**ADDENDUM NUMBER TWO**

**REPLACEMENT ROOFING SYSTEM FOR  
TYNER YFD CENTER**

**FOR THE CITY OF CHATTANOOGA, TENNESSEE  
Contract Number Y-19-021**

**1 ROOF LEGEND**  
 Scale: N.T.S.

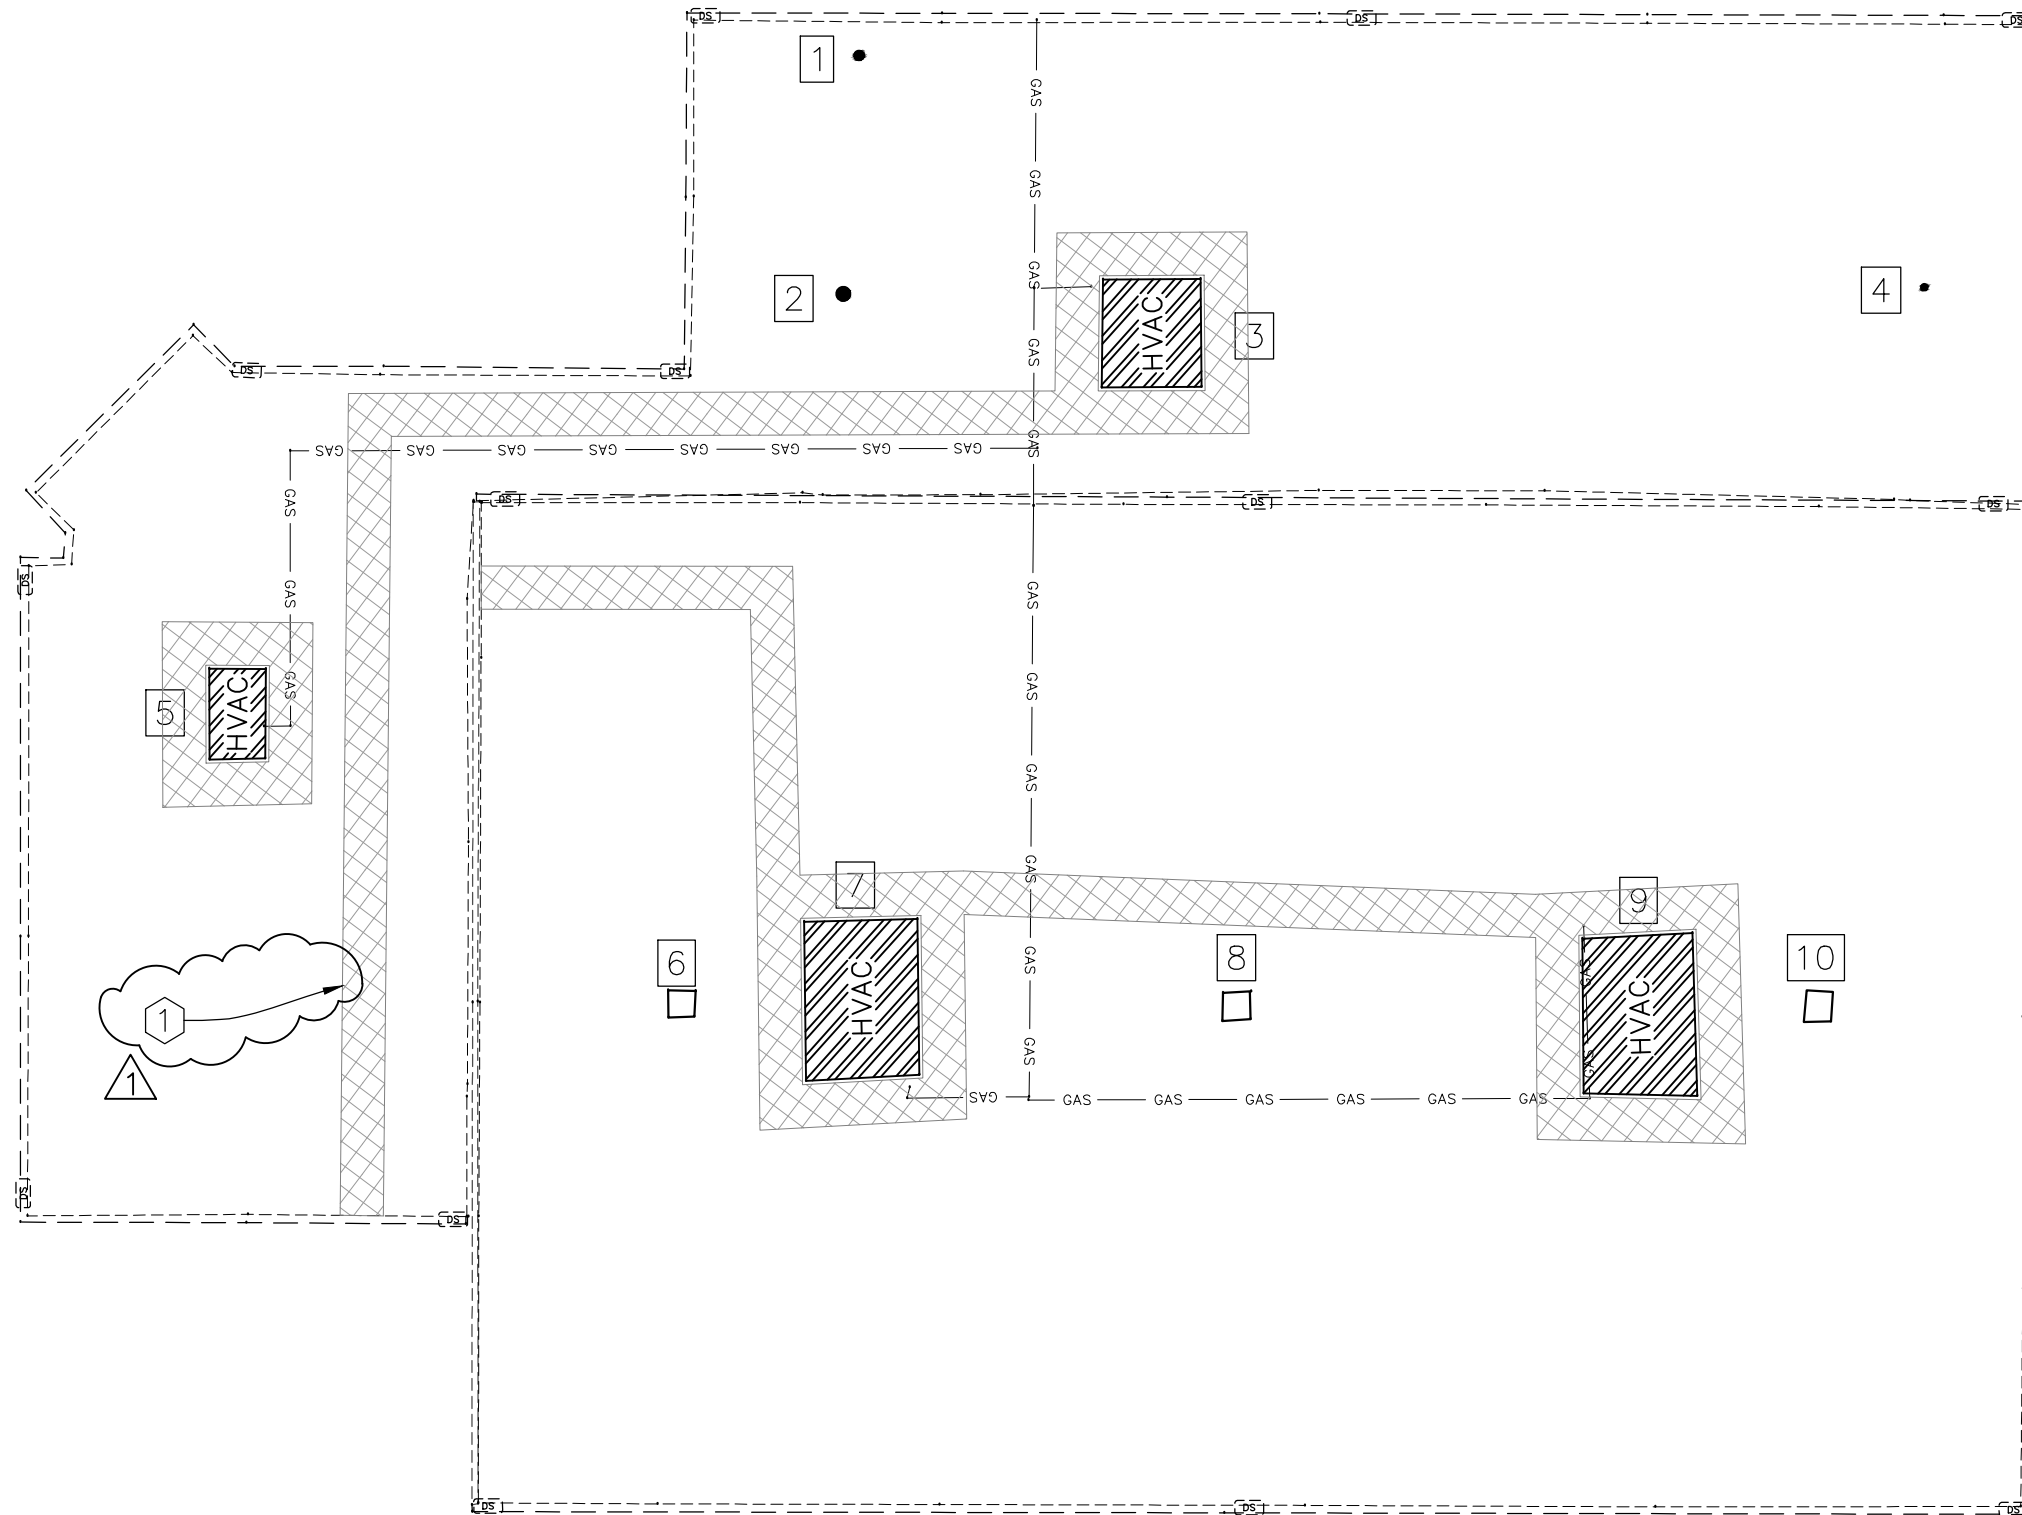
Q12: Bid documents mention walk-pads yet none are shown on the drawings. Is the intent for contractor to install them from fixed ladder access point on roof to upper roof fixed ladder, to HVAC units and around service sides of HVAC units?

REV. 1: ADDED WALK PADS TO THE DRAWING.

A12: A revised layout drawing is being issued with this addendum which shows the locations of proposed walk pads.

① LOCATIONS OF NEW WALK PADS. START WALK PADS AT TOP OF EXISTING LADDERS.
